INFRASTRUCTURE PLANNING
THE INFRASTRUCTURE PLANNING (EXAMINATIONS PROCEDURE) RULES 2010
THE THANET EXTENSION OFFSHORE WIND FARM ORDER

Comments on Appendix 4 to Applicant's Deadline 2 Submission: Applicant's Response to Written Representation – Pilotage
submitted on behalf of the Port of London Authority and Estuary Services Limited
(Rule 8 letter 18 December 2018)

Unique Reference Number	EN010084
Document Ref.	PLA 12/ ESL 12
Author	Winckworth Sherwood LLP
Date	7 March 2019

ESL Sea Room Plan

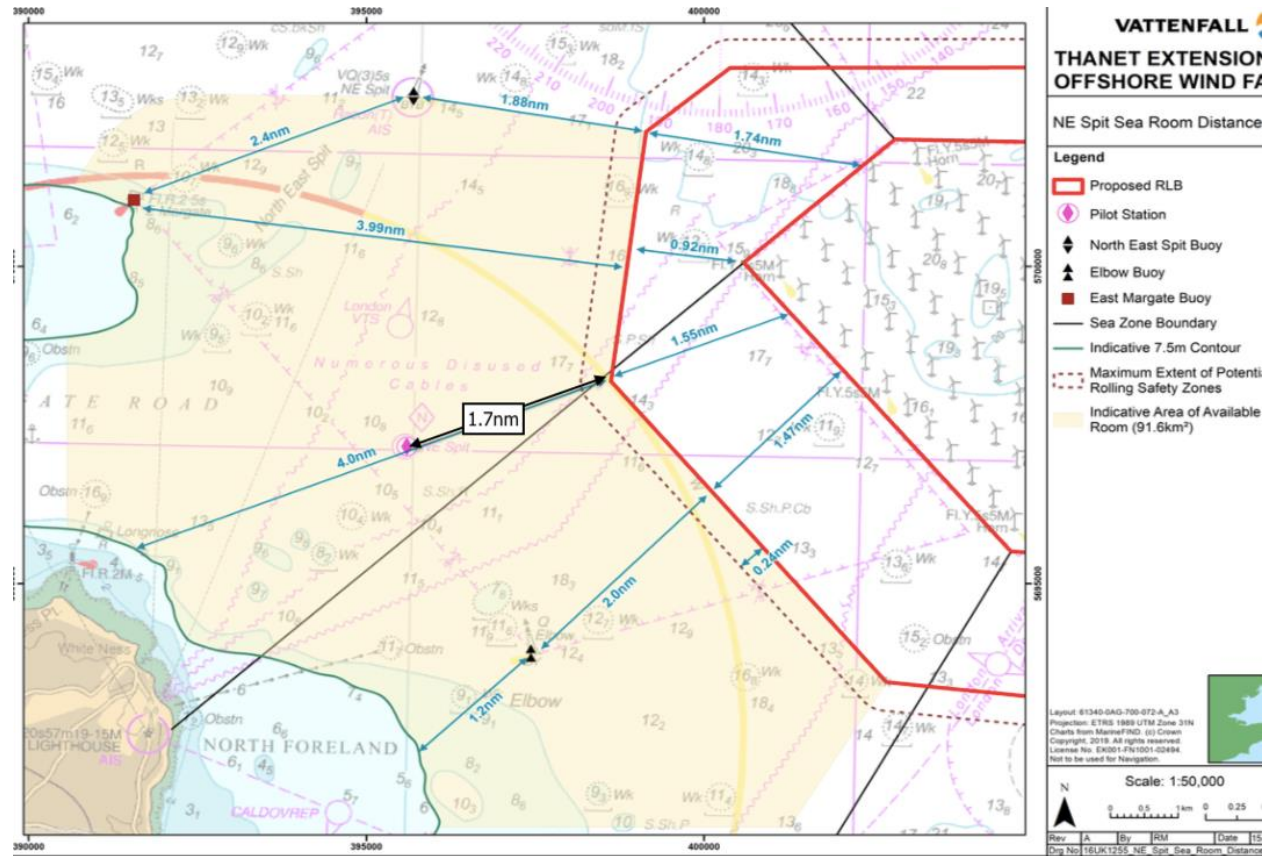
Para	Response summary/extract	PLA/ESL comments
	<p>Sea Room Location of Sea Room for Pilot Transfer</p>	
<p>11 Fig. 1</p>	<p>The Applicant notes, as per the sea room plot provided at Annex B, that the width at the narrowest point is 1.88nm (between the NE Spit buoy and the red line boundary) and greater area of sea room exists to the south (see Figure 1). The area to the south, in the vicinity of the NE Spit pilot boarding station, is where pilot transfers are undertaken (see Figure 2 taken from Figure 48 of Annex 10-1 Application Ref 6.4.10.1) and as such noting the sea room plot at Annex B, there remains sufficient sea room within the NE Spit pilot boarding area post construction of the TEOW for pilot boarding.</p>	<p>(a) The 1.88nm width between the NE Spit buoy and the current extension boundary is not the important one for pilotage operations. For all practical purposes the relevant distance is between the RLB and the charted boarding position, the NE Spit Pilot Station, situated approximately 3nm south of the NE Spit buoy as shown on the ESL sea room plan in Annex 1 to these comments. That is the 1.7nm distance referred to elsewhere in the PLA's submissions.</p> <p>(b) As can be seen from Fig. 1 and the ESL sea room plan, these distances include the 0.5nm buffer zone. The available distance is therefore only 1.2nm.</p> <p>(c) A significant portion of the "greater area of sea room" referred to in para. 11 and shown yellow on Fig. 1 1 Includes a large area West South West of the no anchor line (which will often have ships anchored in it) and shallower water in close proximity to the coast. These waters are not available to most vessels. The Applicant should re-calculate the yellow area so as to show the area that is suitable for use by larger/deeper draught vessels.</p> <p>(d) When the area of sea room was discussed the Applicant agreed that 'clear and available' sea room relates to the no anchoring line and the fact the Margate Roads anchorage can't be assumed as 'clear'. The Applicant confirmed that it was not suggesting that the no anchoring line should be moved (i.e. the</p>

Para	Response summary/extract	PLA/ESL comments
		<p>anchorage reduced in size) in order for more of the yellow area to provide sea room..</p> <p>(e) The conclusion that the sea room plot is sufficient is referenced to the footprint of pilotage acts as shown in Fig. 2 of Appendix 4 - Pilotage/Fig. 48 in the NRA, which represent the spatial extent of pilot transfers (see NRA section 7.2, fourth paragraph). The Pilotage Study section 2.5.2 explains that this Figure (Fig. 13 in the Pilotage Study) “shows the locations where a pilot vessel has reduced speed to less than 10 knots for a period of time, presumably to conduct a transfer. These are centred around the North East Spit ...”.</p> <p>(f) For the reasons explained in section 2.5.2 the Pilotage Study also includes Fig. 14, which shows the tracks of vessels meeting the pilotage criteria at less than 10 knots. The study noted that these vessel. “would likely include vessels slow steaming, waiting for a pilot to arrive”. This additional graphic produced by the Applicant shows an increased interaction (duration) between vessels engaged in pilotage, supporting the PLA and ESL’s view that the act of pilotage has a bigger footprint than just the point of ‘contact’ between launch and ship.</p> <p>(g) The limited period covered by Fig. 14 (see 12(c)) will have affected the size of footprint and the density of traffic. The PLA and ESL believe a longer survey period would have increased both elements.</p> <p>(h) For all these reasons the PLA and ESL believe the sea room plot to be inadequate.</p>

Radar interference – double echo effect

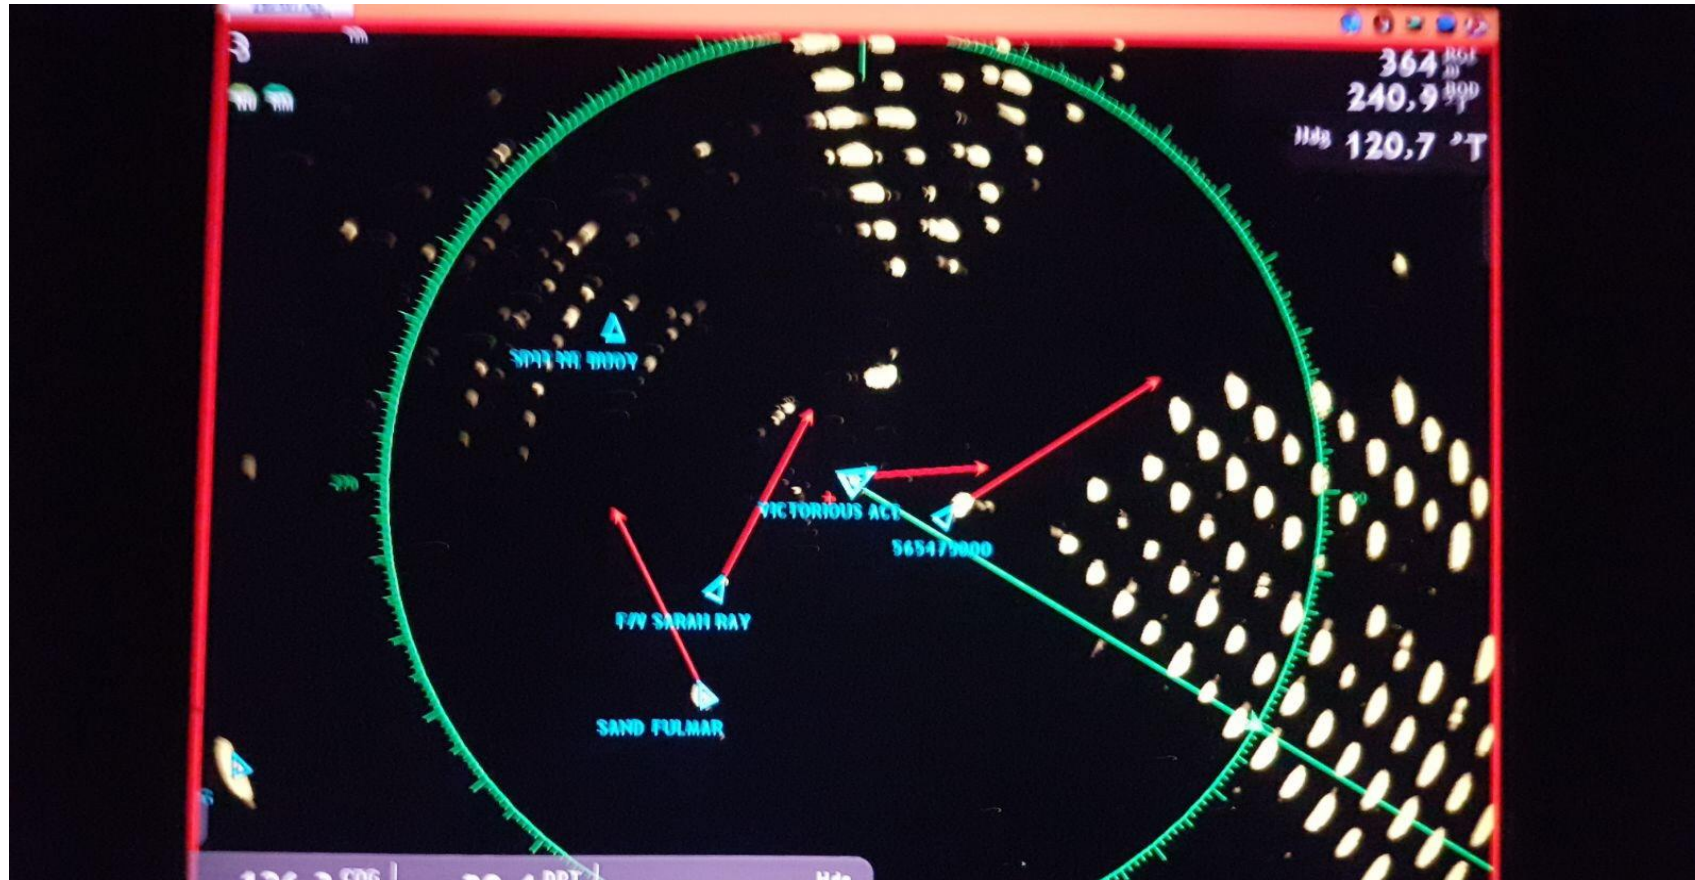
Para	Response summary/extract	PLA/ESL comments
17	Referring to Havens Category vessels, to date the Applicant has not received any risk assessments and logs of incidents for the NE Spit area, and so requests this assessment as it notes this represents an important opportunity to compare the assessment with the NRA undertaken for TEOW.	The PLA does not have a specific risk assessment for Havens vessels at the NE Spit, but is happy to provide what incident and risk assessment data we have to the Applicant to help inform the proposed discussions/workshops ahead.
	Safety Concerns – Other Factors	
19	The Applicant considers that the cause of the radar interaction noted by pilot launch crews is due to the proximity of the pilot launch to the larger vessel when boarding a pilot (likely causing radar reflections) and not the existing windfarm – otherwise it would be expected that the interference would be present at all times whether alongside a “high sided” ship or not. However, it is the case that the interaction seen when a pilot launch is alongside a “high sided” ship will also occur in relation to navigation buoys, other passing vessels or even the Thanet coastline (were the pilot launch close alongside the landward side of a “high sided” ship).	<p>(a) When a pilot launch is in close proximity to large ships, the large scale of the existing TOWF can then swamp the radar screen as a double echo. An example is in Annex 2.</p> <p>(b) As a separate issue, the need to maintain a distance from the wind farm means that in a given sea area (i) the number of vessels will increase and (ii) they will be closer together. This also increases the risk of radar interference.</p> <p>(b) When radar signals are compromised a pilot has to rely on vision. The position can become dangerous in conditions where vision is restricted e.g. by fog.</p>
